**ActewAGL Distribution  
Access Arrangement 2016-21  
ACT, Queanbeyan and Palerang**

**Comments  
on  
ActewAGL Response  
to the  
AER's Draft Decision**

**28 March 2016**

*Figure 1: Residential Peak Gas Demand per Customer*

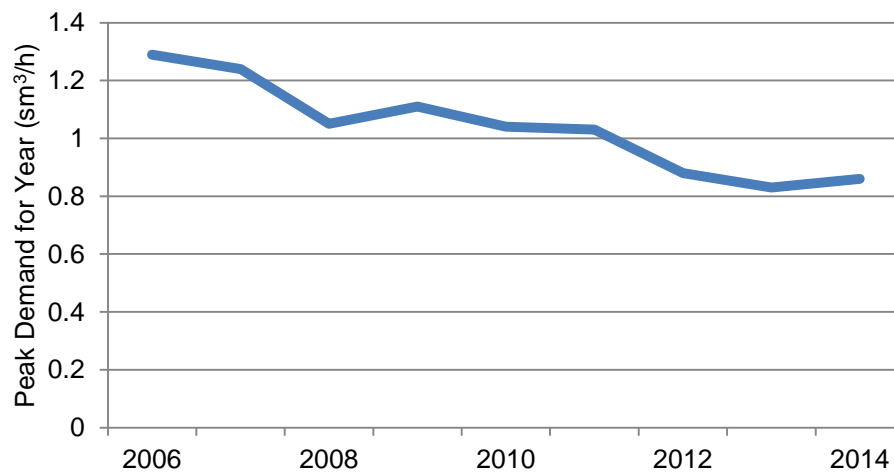
- iii) AAD has applied its estimated 1 in 20 peak hourly gas demand per customer figure to the total number of dwellings it is estimated may be developed in the Molonglo area in order to determine an overall peak load for Network design purposes.
- iv) I consider AAD's estimated peak load is still excessive since:
  - the 1 in 20 peak hourly demand figure is not reliable (see vi) below); and
  - not all new dwellings constructed will connect to gas (see vii) below).
- v) Since 2006, residential gas demand has declined, as illustrated in Figure 1 for actual peak demand, and is forecast to continue to decline<sup>4</sup>.

- vi) I consider it likely that the use of a fixed (2013) 'non-severe' peak hourly gas demand figure will result in progressively increasing overstatement of peak demand forecasts for the period through to 2021. This is because a fixed figure does not provide for potential ongoing decline in peak hourly demand in line with the trend set out in Figure 1, and as overall residential gas demand declines.
